TRC AGENDA

**CITY OF DELAND
THURSDAY JANUARY 19, 2023 AT 1:30 P.M.
CITY OF DELAND TRC MEETING ROOM
DELAND, FLORIDA**

City of DeLand
TRC
SP22-183
JANUARY 19, 2023

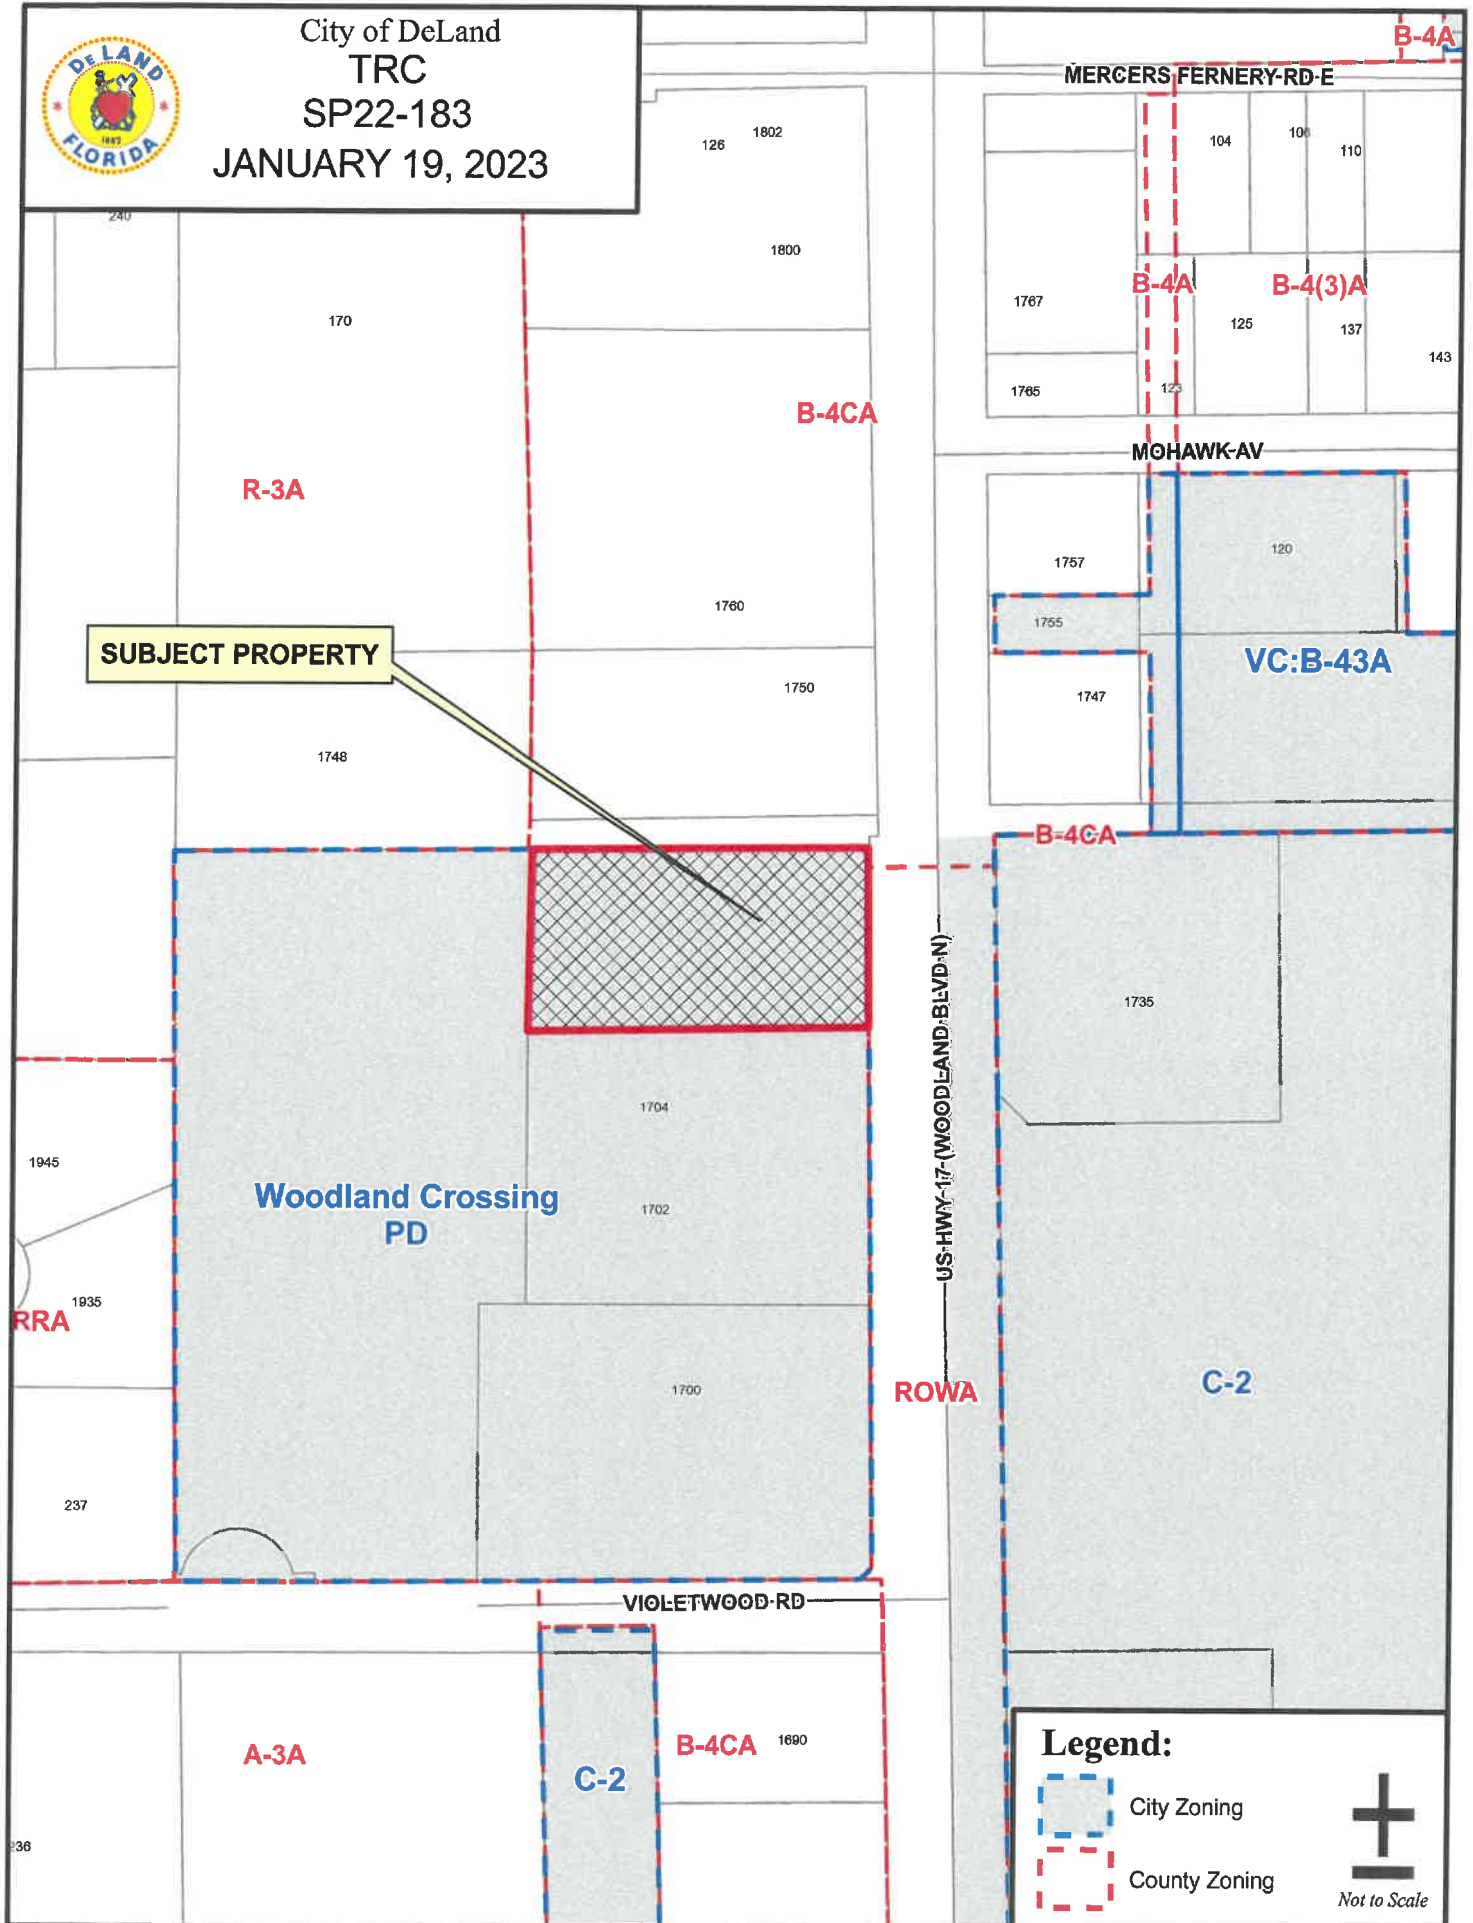
Discipline	Status	Details	Attached To	Created By	Last Updated By	Modifications Required
Forestry	Draft	Specimen Tree Preservation It is likely that you do not have any specimen trees on your property. If this is the case, all numbers should be changed to 0.	L201 TREE SURVEY LS	Mariellen Calabro	Mariellen Calabro	Yes
Forestry	Draft	Minimum Tree Coverage Calculations If your project area is 47,705 sf, your number of trees required is 19, not 3. Your minimum total DBH should be 115" DBH, not 18. Your specimen DBH after development should be 0", not 230". You Non-Specimen DBH after Development should be 230" DBH, not 24". Total DBH after Development should be 230" DBH, not 254" DBH. Your Minimum Tree Coverage Deficit would be -115" DBH, not -236" DBH.	L201 TREE SURVEY LS	Mariellen Calabro	Mariellen Calabro	Yes
Forestry	Draft	FBW-2 Change height for FBW-2 from 40' height to 8' height.	L201 TREE SURVEY LS	Mariellen Calabro	Mariellen Calabro	Yes

Forestry	Draft	TREE What does TREE indicate on the plan?	L201 TREE SURVEY LS	Mariellen Calabro	Mariellen Calabro	Yes
Forestry	Draft	Specimen DBH after Development Your Specimen DBH after Development is not correct. You probably only have 53" DBH of specimen trees, but I can't be sure without identifying oaks by species. Last comment from reviewer: Based on Google Earth Imagery and a field review by the Arborist Tech inspector, you do not have any historic trees on your property.	L201 TREE SURVEY LS	Mariellen Calabro	Mariellen Calabro	Yes
Forestry	Draft	Specimen Tree Preservation You don't have 11 specimen trees on your site. I can't tell how many you have without knowing the species of the trees identified as "oak."	L201 TREE SURVEY LS	Mariellen Calabro	Mariellen Calabro	Yes
Forestry	Draft	TREE and TPF Identify TREE and TPF on legend.	C502 EC PH 2	Mariellen Calabro	Mariellen Calabro	Yes

Discipline	Status	Details	Attached To	Created By	Last Updated By	Modifications Required
Forestry	Draft	TREE and TPF Identify TREE and TPF on legend.	C501 EC PH 1	Mariellen Calabro	Mariellen Calabro	Yes
Forestry	Draft	Oaks Identify oaks by species to determine whether they are protected, specimen, or historic. Last comment from reviewer: Based on Google Earth Imagery and a field review by the Arborist Tech inspector, you do not have any historic trees on your property.	C501 EC PH 1	Mariellen Calabro	Mariellen Calabro	Yes
Forestry	Not Accepted	Minimum Tree Coverage and Specimen Tree Preservation None of your calculations can be verified without tree survey information. If your project area is 47,705, your minimum coverage requirement is 114" DBH. We require an actual survey, not assumed size and approximate location. If your trees are 8" diameter, they are protected trees, not specimen trees. They still require replacement, just not at specimen level. Last comment from reviewer: Oaks need to be identified by species before I can determine whether trees are protected, specimen or historic. Based on Google Earth Imagery and a field review by the Arborist Tech inspector, you do not have any historic trees on your property. Last response: Response: Sheet L201. No trees are anticipated to be removed as part of this development; therefore, no replacement of trees is needed.	L201 TREE SURVEY LS	Mariellen Calabro	Mariellen Calabro	Yes

Forestry	Not Accepted	Tree Protection Area Show the limits of the Tree Protection Area on your plan. Last comment from reviewer: It looks like you have construction within the Tree Protection Area. As no machinery is allowed within the Tree Protection Area, underground utilities should not be included in this area. Please re-route or remove this section from Tree Protection Area. Last response: Response: Sheet L201: Tree Protection Area shown on plan.	L201 TREE SURVEY LS	Mariellen Calabro	Mariellen Calabro	Yes
Forestry	Not Accepted	CMY Add DBH, container size, and other specifications. Last comment from reviewer: Add minimum root ball size and increase size to match grade 1 specifications for at least a 3" caliper tree. Last response: Response: Sheet L201: DHB, container size and other specs added to plan	L201 TREE SURVEY LS	Mariellen Calabro	Mariellen Calabro	Yes

You are not providing 230" specimen trees and 24" of non-specimen trees. They were already there.				
		Last response: Response: Sheet L201: Project is providing a total of 230" of specimen trees and 24" of non-specimen trees. Total DBH provided: 254"				
		Landscaping Calculations				
Planning	Draft	The LS calculations from the previous submittal have been removed. Please add that information back onto the plan or provide an additional sheet, if needed.	L201 TREE SURVEY LS	Kendall Story	Kendall Story	Yes
Design Standards & Elevation						
Planning	Not Accepted	Shall follow the Community Design Standards 33-94 – to be approved by city architect as part of the site plan approval. Provide elevations.		Kendall Story	Kendall Story	Yes
		Last comment from reviewer: Per City Architect, more information is needed about the colors being used. See email "Arch Checklist Comments" dated 1/3/22				
		Last response: Response: Elevations included with this submittal.

access easement				
Planning	Not Accepted	Provide a copy of the easement agreement for the private roadway to the north.		Kendall Story	Kendall Story	No
		Last comment from reviewer: Not yet received				
		Last response: Response: Owner is sending easement via email to the City

Discipline	Status	Details	Attached To	Created By	Last Updated By	Modifications Required
PD Amendment						
Planning	Not Accepted	The proposed site plan is different than the one that was approved with the amended PD agreement (dated 5-31-22). This will require a second amendment to the PD. Last comment from reviewer: An amendment is required. Last response: Response: We are in discussions with City staff to figure out the best way to move this forward and what will be required		Kendall Story	Kendall Story	No
Max. foot candles						
Planning	Not Accepted	The Max. foot candles at the property line must be .5 or less. 33-94.03(g)(2) Last comment from reviewer: Repeat comment Last response: Response: Sheet P101: Site lighting has been revised to minimized foot candles at PL.	P101 PHOTOMET RICS PL	Kendall Story	Kendall Story	Yes

City of DeLand
TRC
SP22-232
JANUARY 19, 2023

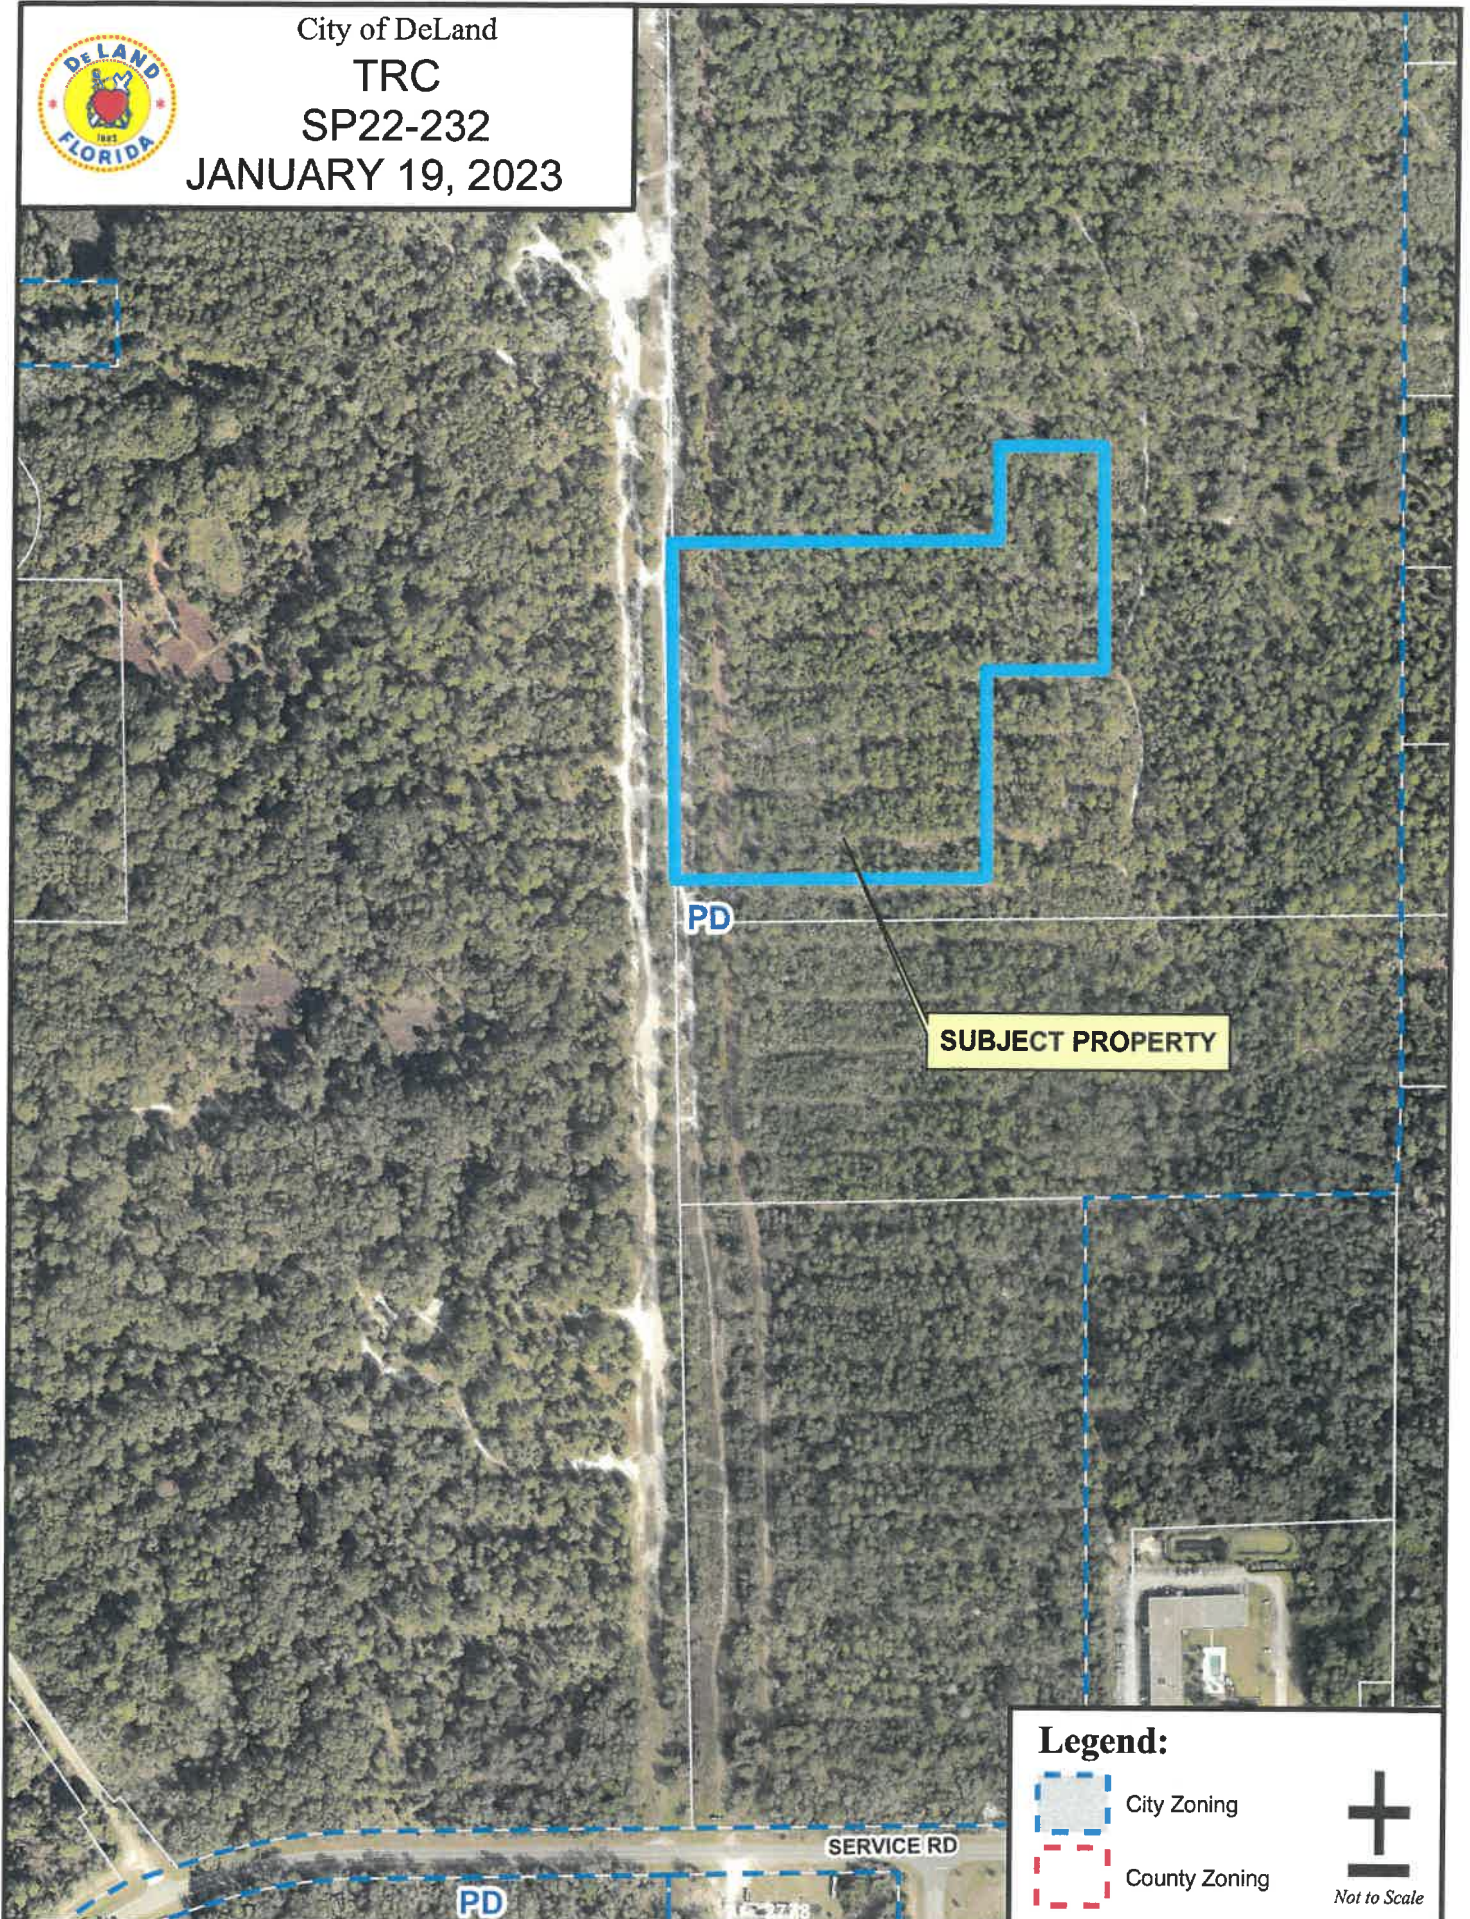
Discipline	Status	Details	Attached To	Created By	Last Updated By	Modifications Required
Tree Barricade						
Forestry	Not Accepted	Add Tree Barricade Detail to your plan or add a note that there are no trees in or immediately adjacent to your proposed project area.				
		Last comment from reviewer: This comment will remain open until the results of the historic tree survey and tree replacement calculations have been provided.				
		Last response: 1. Comment: Add Tree Barricade Detail to your plan or add a note that there are no trees in or immediately adjacent to your proposed project area. Response: As discussed in TRC, there are no trees to be preserved within the limits of the stockpile, as defined by the staked erosion control. Tree replacement fees will be based on the approved matrix within the Phase I preliminary plat. We are preparing an inventory of historic trees, the results of which will be provided to the City and incorporated into the replacement calculations prior to approval.	C-300	Mariellen Calabro	Mariellen Calabro	Yes

Tree Survey						
Forestry	Not Accepted	No tree survey data has been provided. Has this area already been cleared?				
		Last comment from reviewer: This comment will remain open until the results of the historic tree survey and tree replacement calculations have been provided.				
		Last response: Comment: No tree survey data has been provided. Has this area already been cleared? Response: This area has not been cleared. See response above.	C-300	Mariellen Calabro	Mariellen Calabro	Yes
Plan sheet title						
Planning	Draft	The plan sheet is labeled "Phase 2 Stockpile Plan" but the stockpile limits are in both phases 2 and 3. Please clarify.	C-102	Melissa Winsett	Melissa Winsett	Yes
Cover Sheet						
Planning	Not Accepted	Cover Sheet – Comments: 1. The cover page needs to show additional site location details. For clarity and context, show how the proposed site is part of the Crosswind DeLand ODP and Phases 1 and 2. 2. Please provide a statement of intended use including when the site would be operational. 3. Please include all design professionals including the name of the landscape architect. 4. Please include a note indicating the proposed timing of the temporary use.	C-100	Carol Kuhn	Melissa Winsett	Yes

Sufficiency Comment: Please revise the enlarged Site Map to show the boundaries of the stockpile. As currently shown, it appears that the stockpile is outside of Phase 2 and it's unclear whether it's in Phase 3.

Sufficiency Comment: Note #4 specifies Phase 2, but it appears that part of the stockpile is in Phase 3. Please clarify and modify the note and plan as needed.

Sufficiency Comment: Part of the stockpile appears to be located within Phase 3. Please clarify and modify the response as needed.

The site plan submitted lacks sufficient details to provide detailed comments. Please provide a site plan sheet that address the planning comments. This sheet should be separate from the Grading sheet and provide context to the surrounding development and address the planning comments. Also, include a separate Landscape Plan to address Tree Protection Area impacts and revegetation of site. Comments below are general in nature. The resubmittal should provide dimensioned drawings and detailed descriptions for the proposed stockpile, including context related to the entire development site.

Sufficiency Comment: The proposed access remains unclear. Please provide information on how the stockpile will be accessed. Where will heavy equipment and vehicles be traveling? How will workers access the site? Additionally, where will the stockpile be located within the 11.17-acres?

Sufficiency Comment: Per the revised plans, staff is able to see that the stockpile is also in Phase 3. Please update the plans and response to clarify this.

Sufficiency Comment: The comment does not address tree impacts; therefore, this part of the comment is still outstanding.

Sufficiency Comment: Noted. Comment is still outstanding pending the receipt of an approved tree survey. Plans will need to be updated to show tree removal and tree mitigation calculations.

Response: The stockpile will be operated during the same hours as the Phase 1 construction and in accordance with the approved PD. See note #5 on sheet C-100.

Response: The stockpile will be used until such time as this portion of Phase 2 is constructed. See note #4 on sheet C-100.

Response: As discussed at TRC, we have included a preliminary engineering plan in the plan set demonstrating the planned water, sewer and drainage intent for this area of Phase 2. See sheet C-400.

Response: It is not beneficial for the stockpile to be located in Phase 1 as we are developing lots in that phase and the dirt is in the way. Wetland #8 is shown on sheet C-300 and as discussed, there is a double row of silt fence on the wetland setback line, 25 ft offset from the wetland line.

Response: Wetland #8 is shown on sheet C-300. No impacts are proposed.

Response: As mentioned above and at the TRC, no trees within the limits of the stockpile erosion control will be saved. Final tree removal and mitigation calculations will be provided once the historic tree survey has been completed.
